## 2.0 COMMENTS ON THE DRAFT EIR AND RESPONSES

### 2.1 COMMENT LETTERS RECEIVED ON THE DRAFT EIR

| <b>Table 2-1</b><br><b>Comment Letters Received for the</b><br><b>Bonny Doon Limestone Quarry Boundary Expansion Project and</b><br><b>Reclamation Plan Amendment Draft EIR</b> |   |      |

Figure 2. Turbidity infiltration test #1 at southeast corner of quarry pit

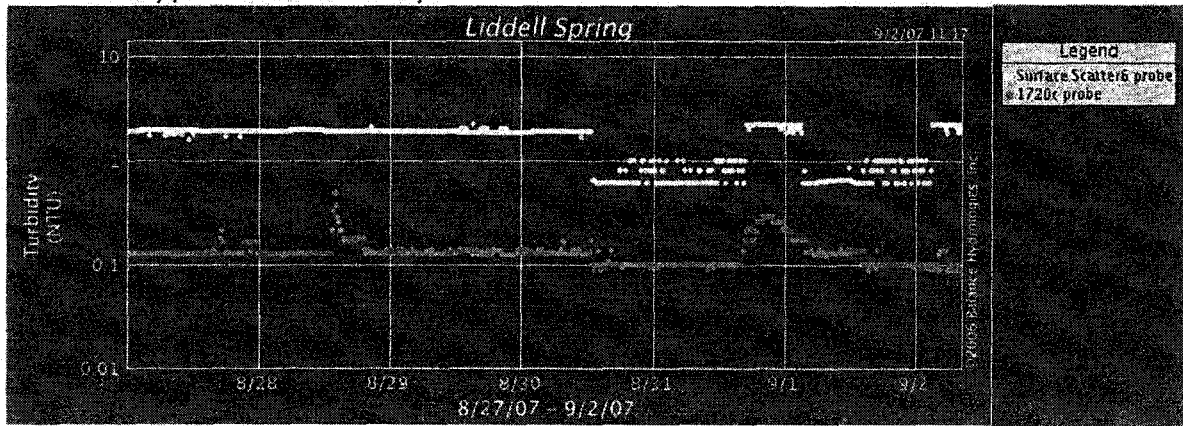
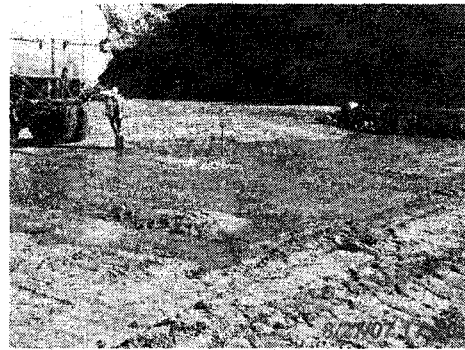
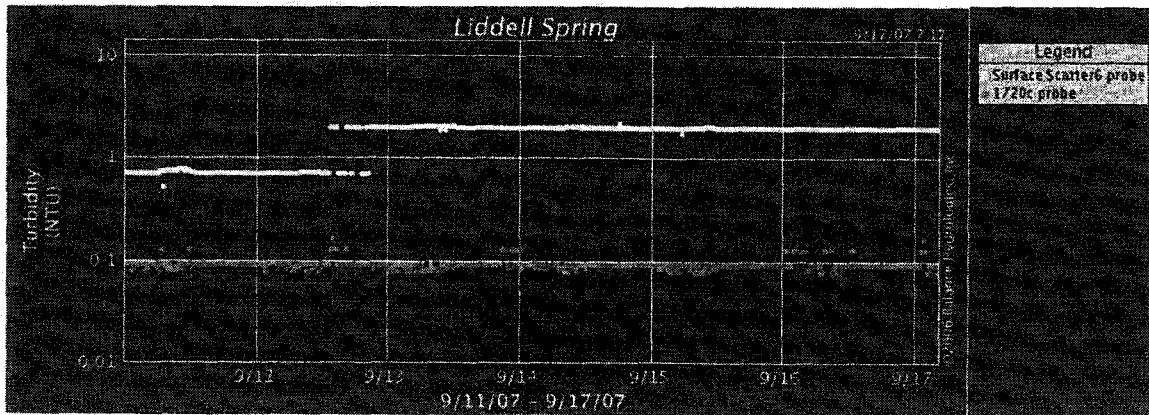
Because this turbidity change is within the resolution range of the sensor, a second, larger amount of water was used late on the afternoon of August 29, 2007 after the pond had dried out. In this second test, approximately 18,000 gallons of water was introduced, which created a pond 70' by 60' with a maximum water level of 11.4". This maximum water level is comparable to the maximum water level measured by Nolan and Johnson, as reported in the Technical Appendix (Figure 11). The massive discharge of water onto the floor caused a high turbidity in the resulting pond, up to 1,500 NTU during the water dumping. If we assume the relationship between suspended

sediment concentration and turbidity, as shown in Figure 41 of the Technical Appendix, is applicable to the data at Liddell Spring, this water pond contained several cubic feet of suspended materials. Leakage or infiltration from the pond occurred as documented by Nolan and Johnson, *circa* 4.5" per day initially and somewhat less subsequently. However, no turbidity values greater than 0.2 NTU were observed within the time frame (6-7 hours) suggested in the Technical Appendix. **In fact, no turbidity values greater than 0.2 NTU were observed within 48 hours.**

There were two very small turbidity spikes (Figure 2), one in the afternoon of August 28 and the other in the afternoon of August 31. These small spikes were undoubtedly related to blasts that occurred several hours prior to their occurrence, within the characteristic response time. However, there is a slight possibility that these spikes are the compound effect of the infiltration tests and the blasts. The spike which occurred after the second, more substantial infiltration test, was more than 48 hours after the water was introduced, and the maximum magnitude was a mere 0.3 NTU, certainly not what Nolan and Johnson were suggesting.

Figure 2 - Sierra Club Letter Report

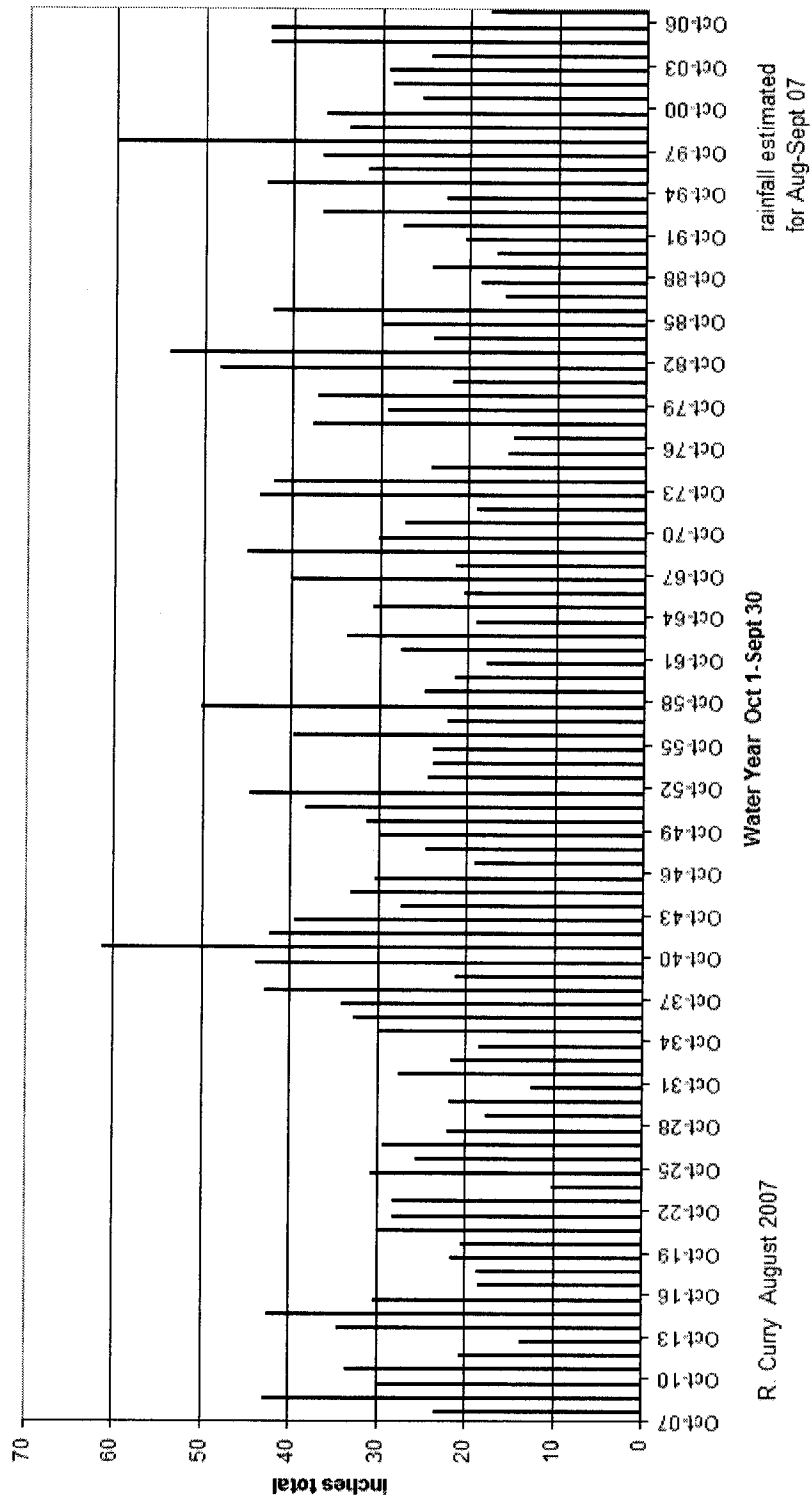
Figures 2 and 3 are plots of the Santa Cruz water year data (Oct. 1 of prior year to Sept. 30 of the named year) with an added tabulation and plotting of a weighted cumulative 3-year precipitation value that assesses the potentials for carry-over water storage for diminishing amounts of prior years' rainfalls. The weighted values are calculated by multiplying the amount of rainfall of the year in question by 4, adding that to 2 times the rainfall of the prior year and adding that total to the amount for the year before that; and then dividing the total by 7. This provides an index of potential contribution of prior years to the water stored in a large karst system. All data are from the California Data Exchange Center and Western Regional NOAA Climate Center.
